Reply to Editor

Editor Decision: Publish subject to minor revisions (review by editor) (21 Jul 2021) by Thom Bogaard

Response: Thank you for your letter and for the decision (Publish subject to minor revisions) concerning our manuscript (ID: hess-2020-412). The following comments are valuable and very helpful for improving our work. At the same time, we thank you for giving us the opportunity to revise the manuscript. We have studied and analyzed comments carefully and have made many corrections which we hope meet with approval.

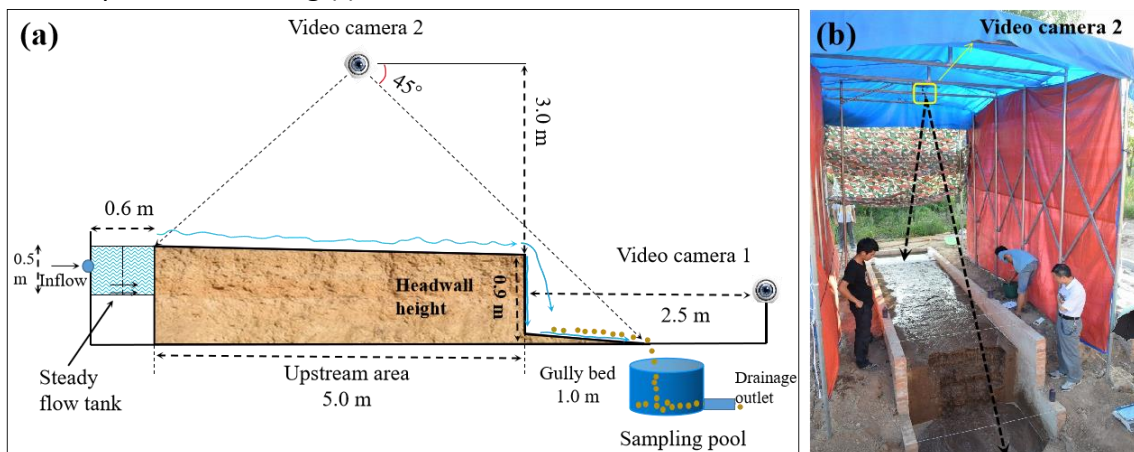
Q3. Fig 2: photo panel description should be in figure caption (Figure 3. Panel a) ..., b) ... etc.

Q4. It is OK to indicate things in the photo but the figure description should be below. Please only use black and white for letters, lines and symbols as 'colors and especially red is not visible to everybody. Also try to align the text. Use black or white also for panel indication without grey background

Response: We revised the Figure 2 according to your suggestion. The revised figure 2 as following. Besides, the figure 1 was also revised.

Figure 3. Sketch of jet flow at gully headcut (a) and plunge pool at gully bed (b)

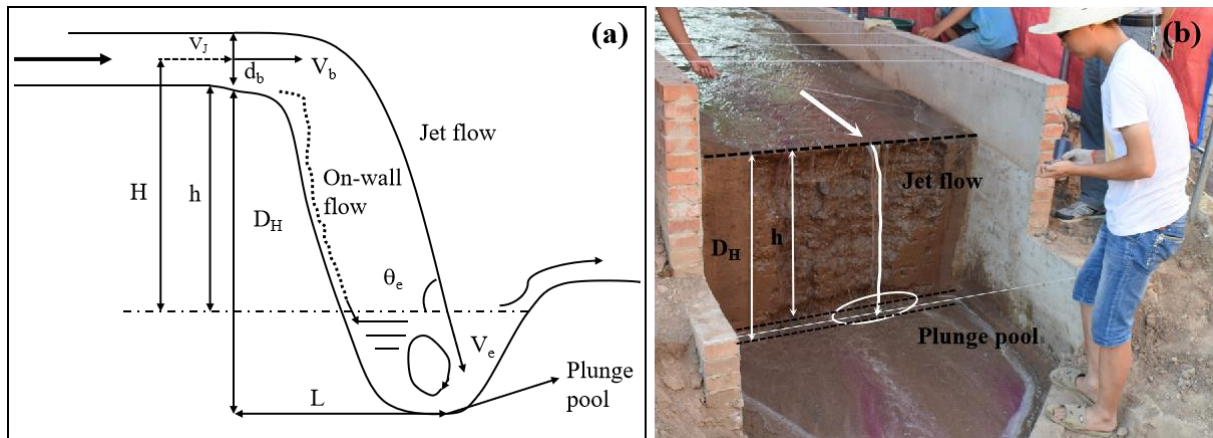
Q1. Fig 3: same

Response: The figure 3 was revised as following:

Figure 4. Temporal changes in jet properties of headcut and their relationships with inflow discharge

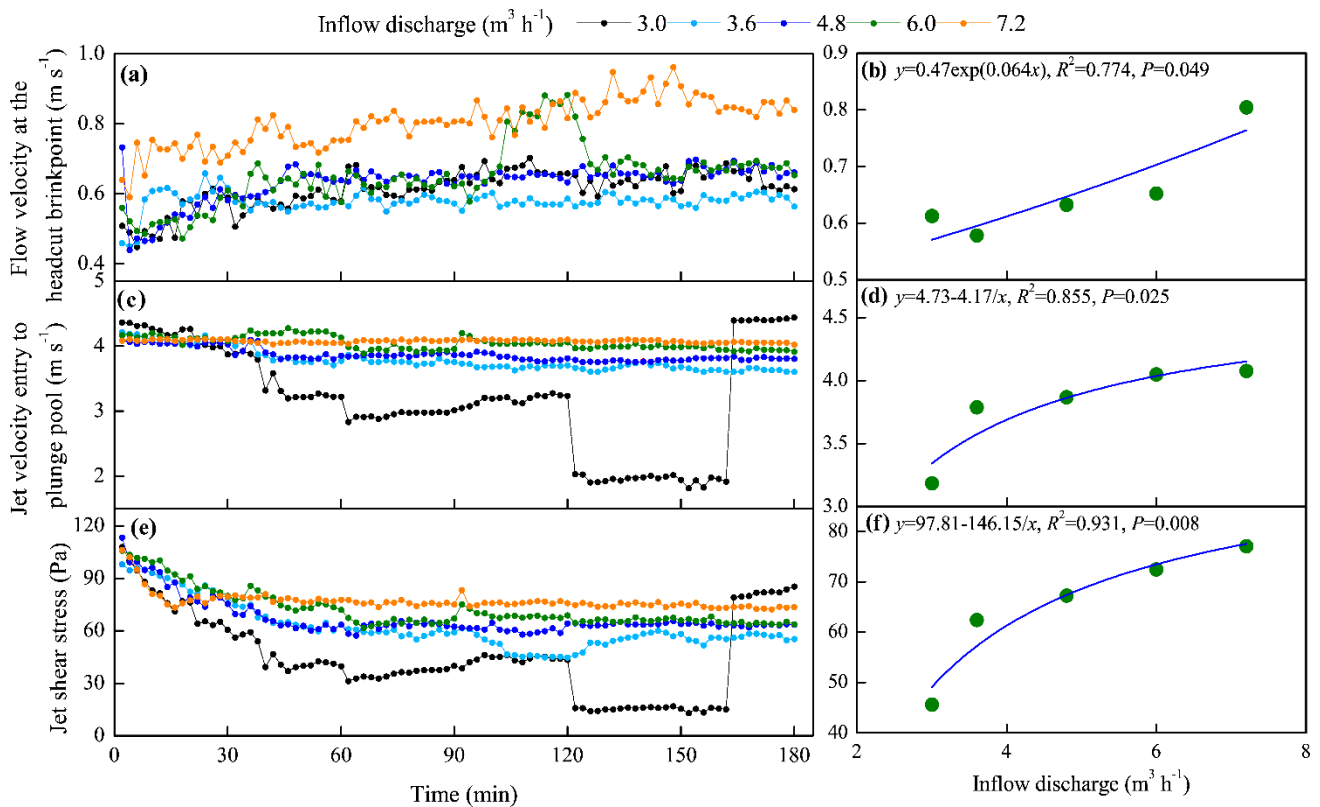
Q2. Fig 4: in panel b-d-f, please align formula info (put all three in same location in their panel)

Response: The figure 4 was revised as following:

Figure 5. Temporal changes in runoff regime of upstream area and gully bed and their relationships with inflow discharge

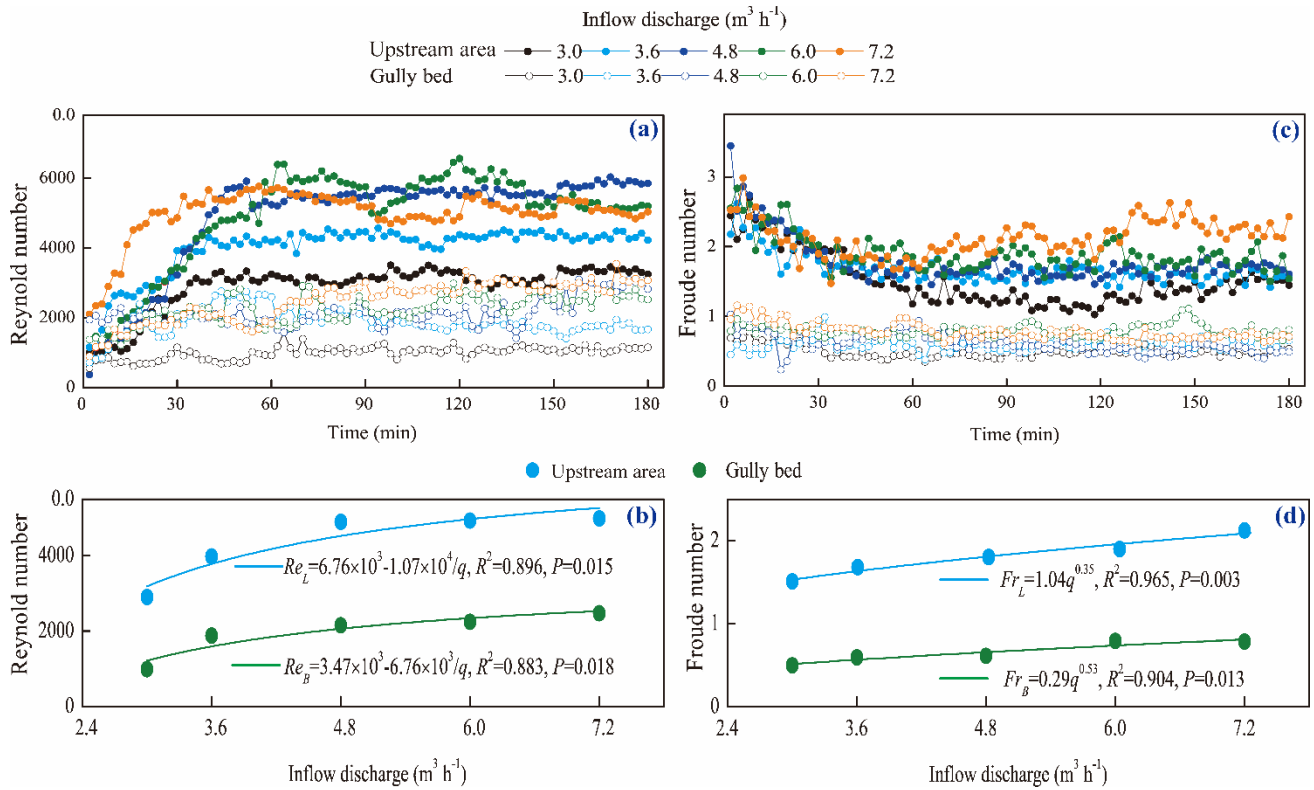
Q5. Fig 5: please do not use red text in figure. Try to place legend outside the box (fitting formula is OK, but legend and extra text (like you do in fig 8)

Response: The figure 5 was revised as following:

Figure 7. Temporal changes in runoff shear stress and stream power of upstream area and gully bed and their relationships with inflow discharge

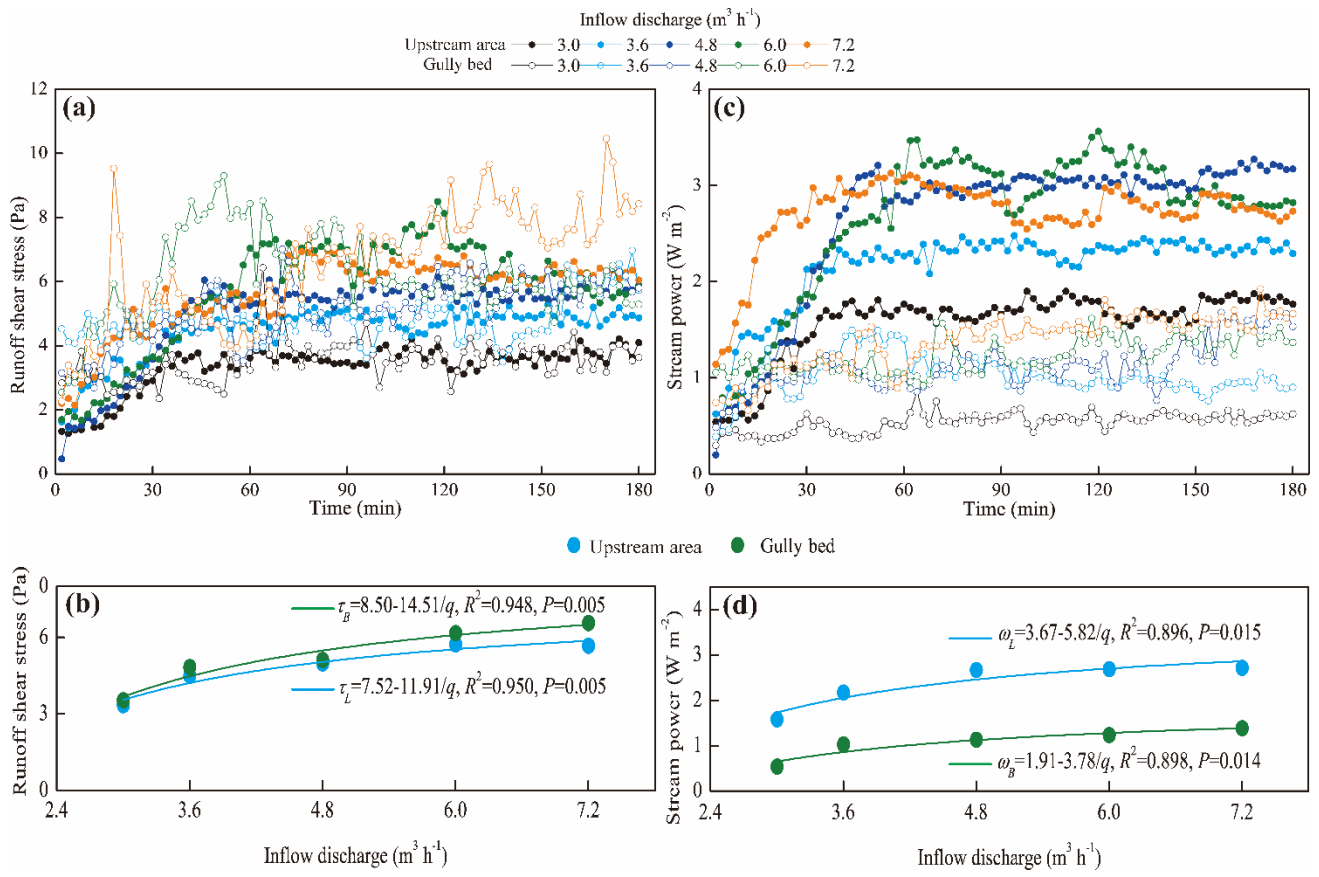
Q6. Fig. 7: same as fig 5

Response: The figure 7 was revised as following:

Figure 9. Total energy consumption (a) and their proportions (b) of upstream area, gully head and gully bed, and the total energy consumption and rest flow energy (c) and their proportions (d) with under different inflow discharge conditions

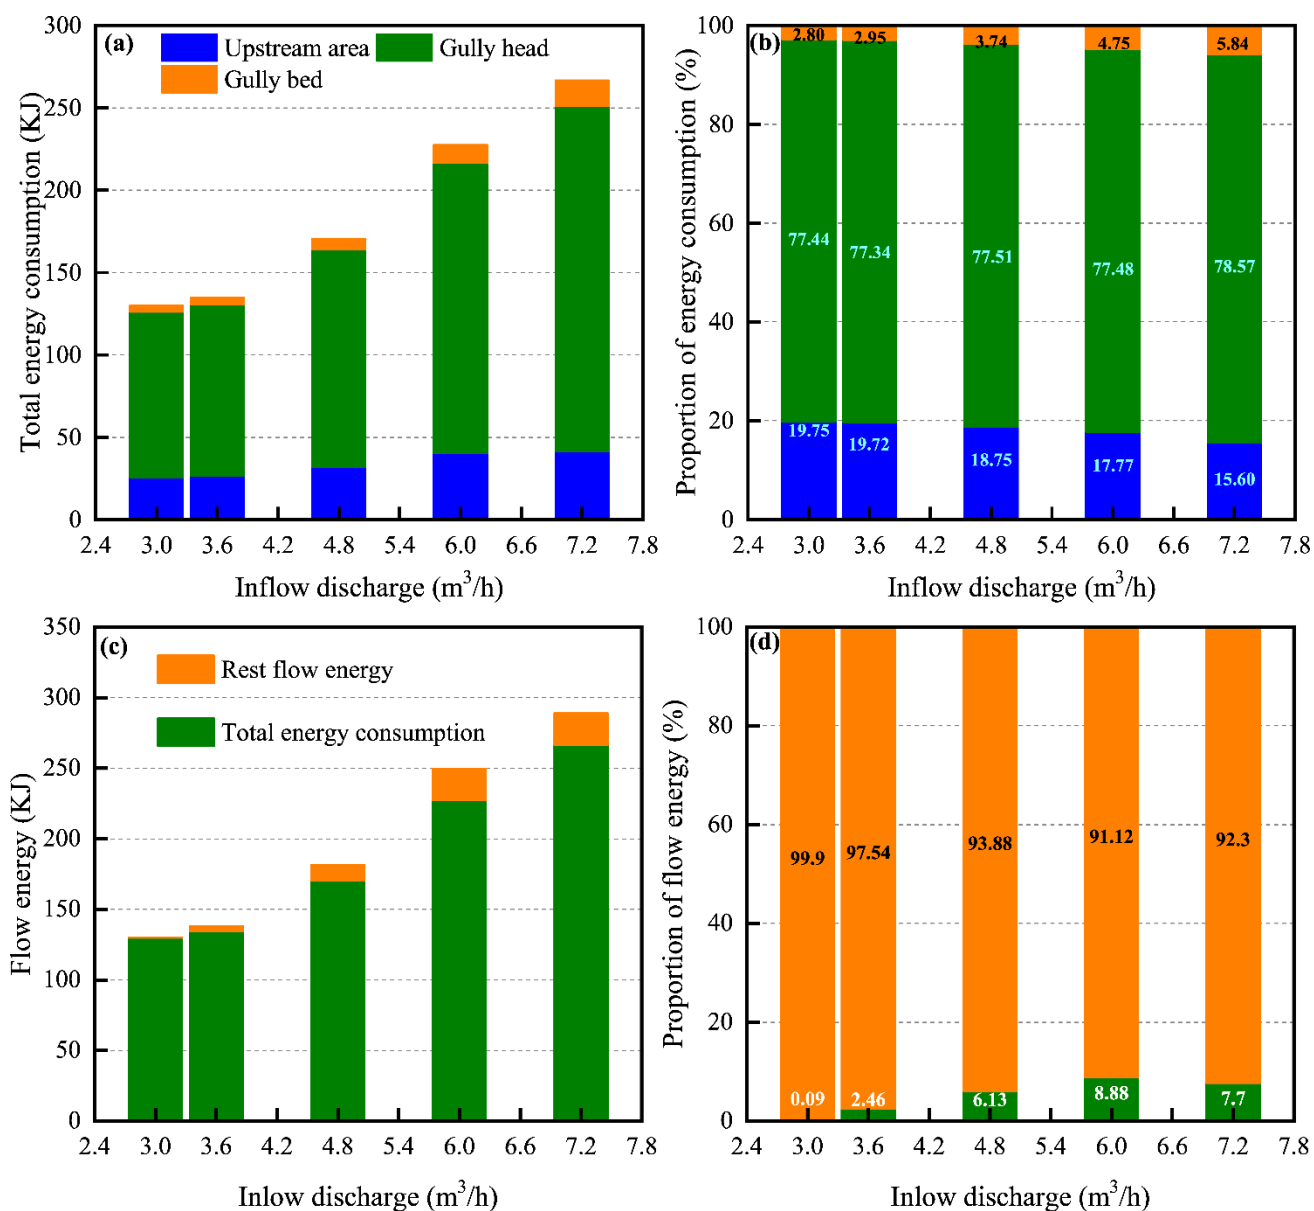
Q7. Fig 9: use black for panel indication. Describe panel in figure caption

Response: The figure 9 was revised as following:

Figure 10. Temporal variation in soil loss rate of the "upstream area—gully head—gully bed" system (a), upstream area (b), gully head (c) and gully bed (d)

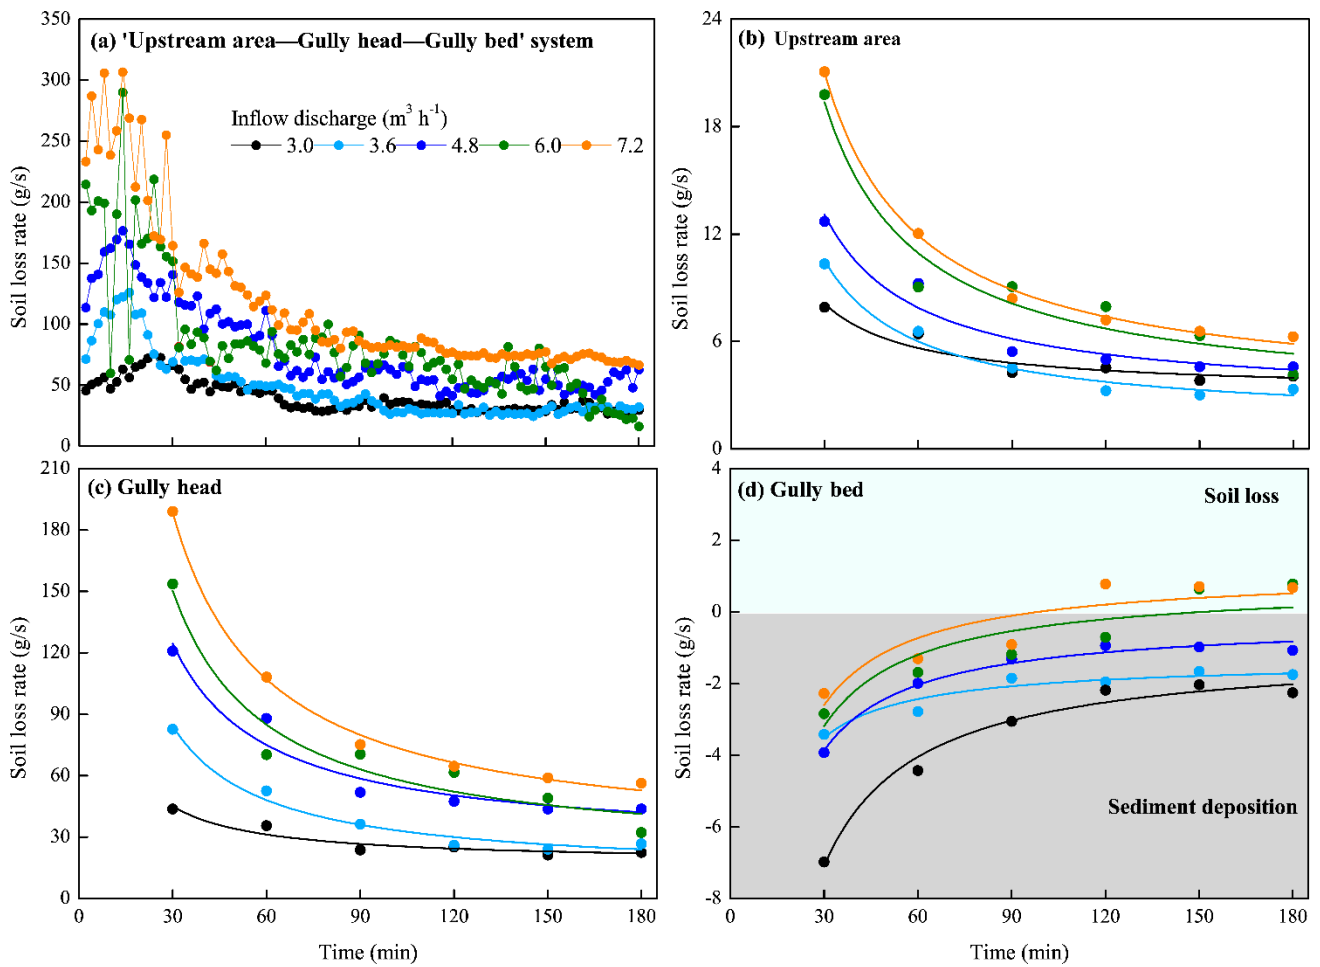
Q8. Fig 10: use black for panel indication and text in figure

Response: The figure 10 was revised as following:

Figure 12. Relationships between soil loss rate of upstream area, gully bed and gully head and runoff hydraulic and jet properties

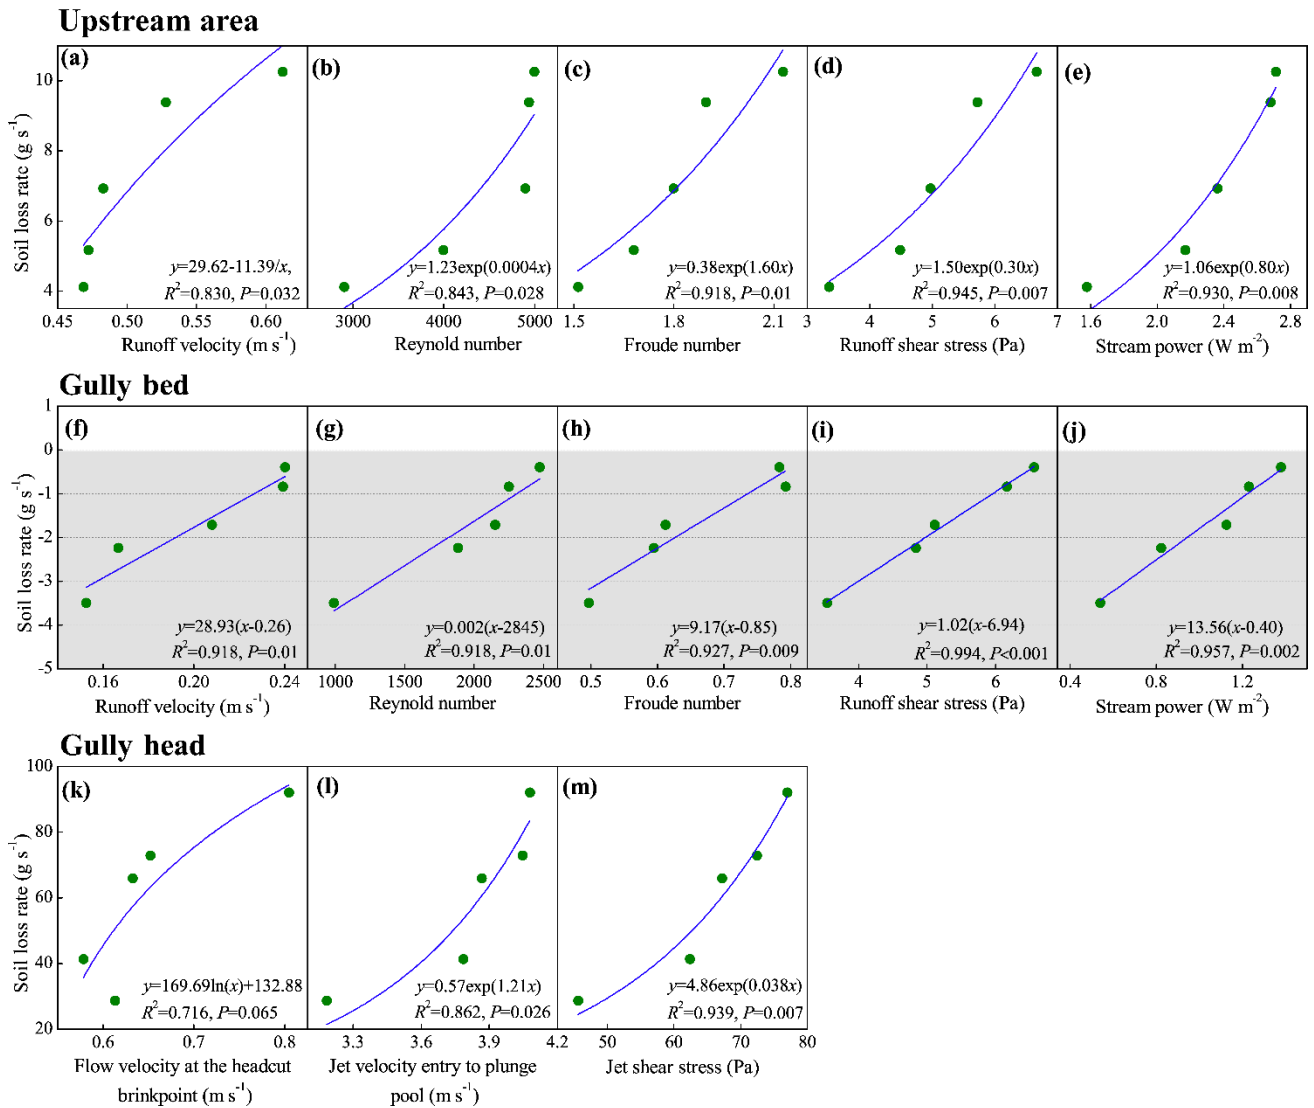
Q9. Fig 12: try to align formula text in panels to be at same height and distance from side

Response: The figure 12 was revised as following:

Figure 13. Synchronous change of soil loss rate of “upstream area-gully head-gully bed” system and total energy dissipation during headcut erosion

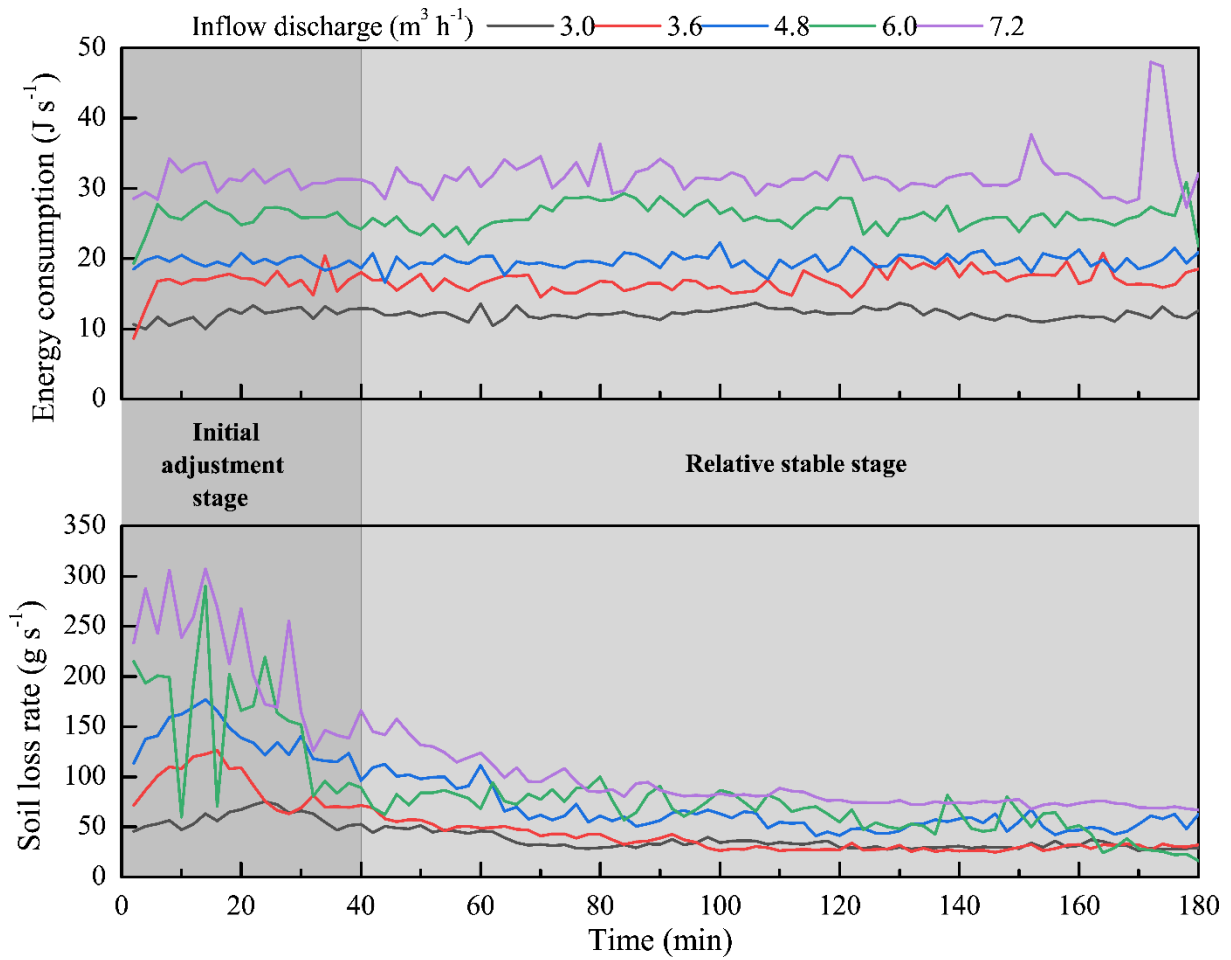
Q10. Fig 13: use two grades of grey to indicate parts, use black panel indications

Response: The figure 13 was revised as following:

Figure 14. Relationships between soil loss rate of “upstream area-gully head-gully bed” system (a), upstream area (b), gully head (c) and gully bed(d) and energy consumption

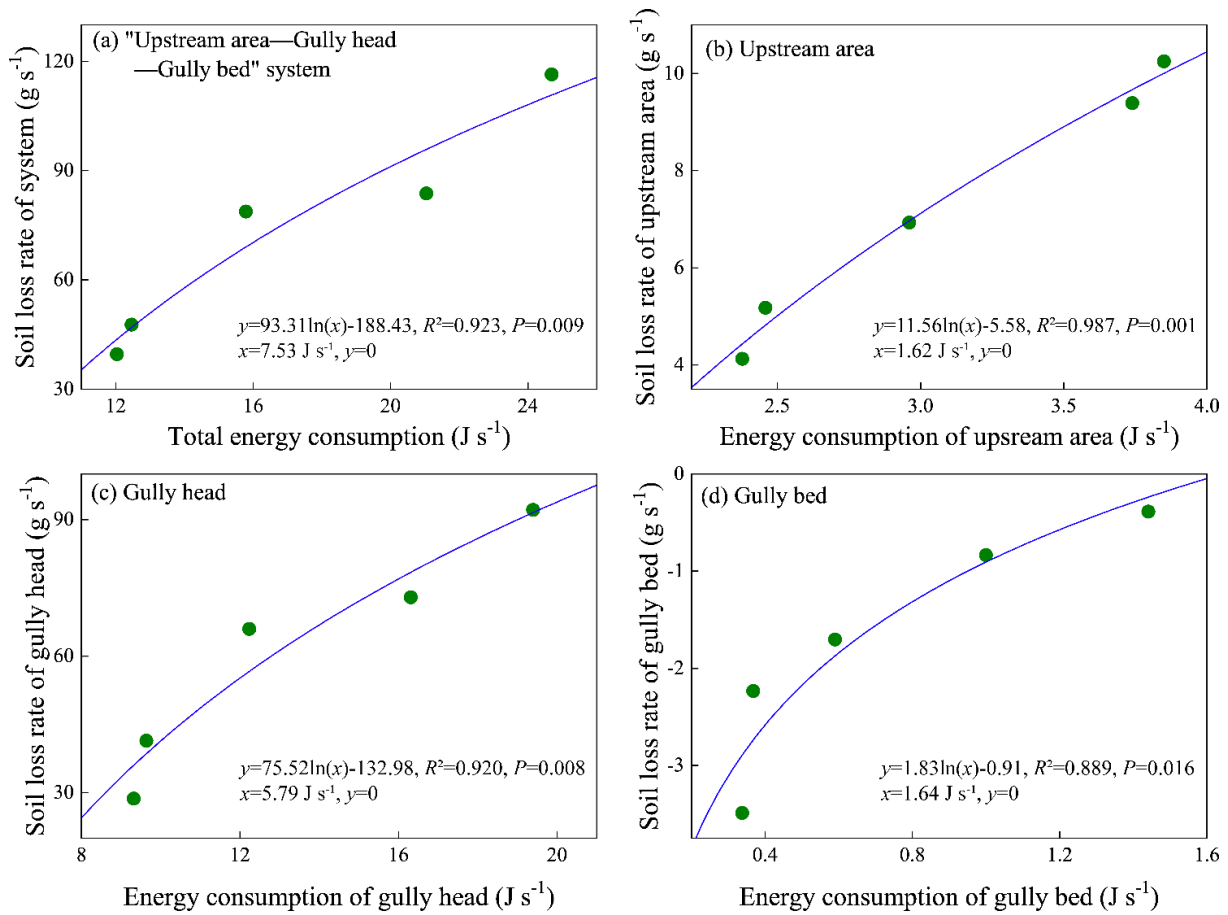
Q11. Fig 14: black text. Formula does not need bold letter font

Response: The figure 14 was revised as following:
